Product Upgrade Bulletin 161109REV

PRODUCT(S) AFFECTED:
Fleetwood Storm;
Holiday Rambler
Vacationer XE

SUBJECT:
Installing a
Compressor Delay
Timer Relay

ISSUE DATE:
December 2016

Figure 1

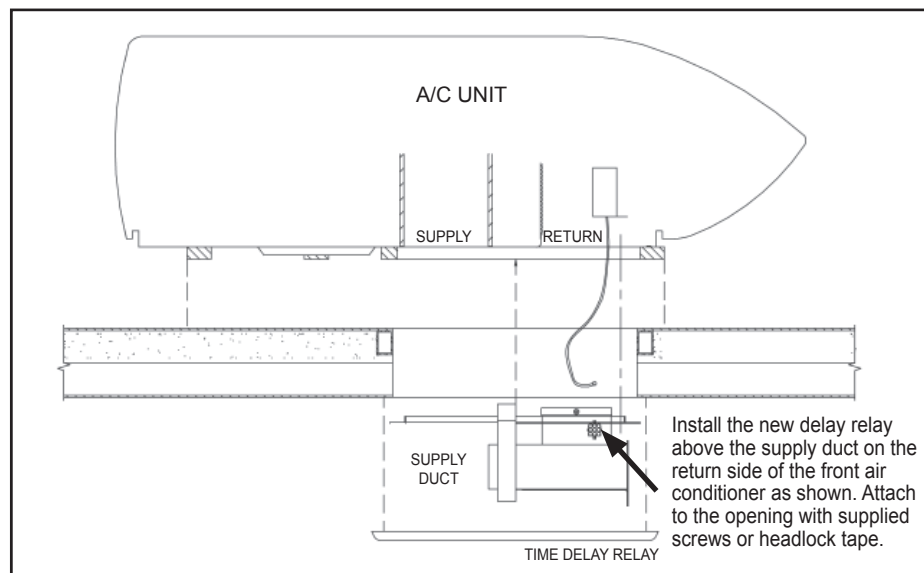
1. Park the motor home on dry, level pavement. Turn off the ignition and remove the key. Place the transmission in PARK and set the parking brake. Turn off the ignition and remove the ignition key. Maintain control of keys while work is performed.
2. Remove the chill grille from the ceiling at the front air conditioner to expose the duct work.
3. Install the new delay relay (part # 10078336) in the opening for the front roof air conditioner, above the supply duct. Fasten using the screws that come with the kit or by using headlock tape. See Figure 1.

Figure 2

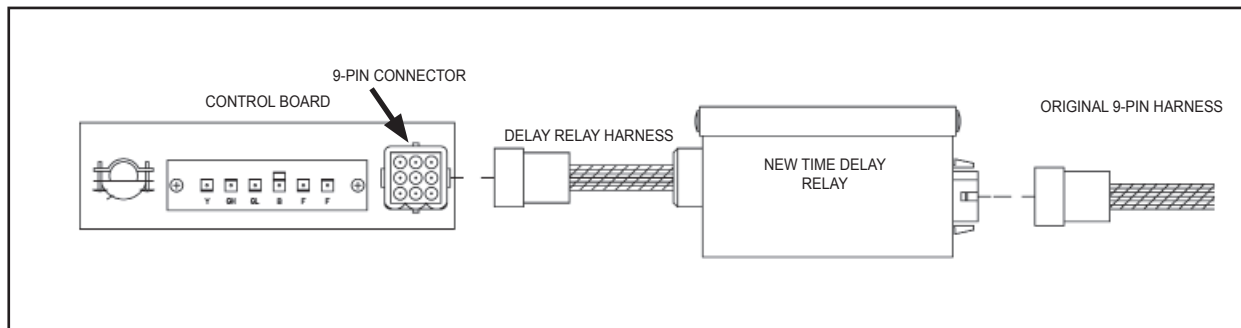
4. Unplug the 9-pin harness from the connection at the upper control board, and plug it into the 9-pin connector on the delay relay. See Figure 2.
5. Plug the harness for the new delay relay into the same connector from which the original 9-pin harness was unplugged in the previous step. See Figure 2.
6. Set the time delay setting on the new delay relay to 15 seconds; it may be adjusted as needed. See Figure 3.
7. Test operation of the system by starting the generator and listening for the sound of the air conditioner's compressor to turn on. Correct as necessary.
8. Reinstall the chill grille to complete the repair.
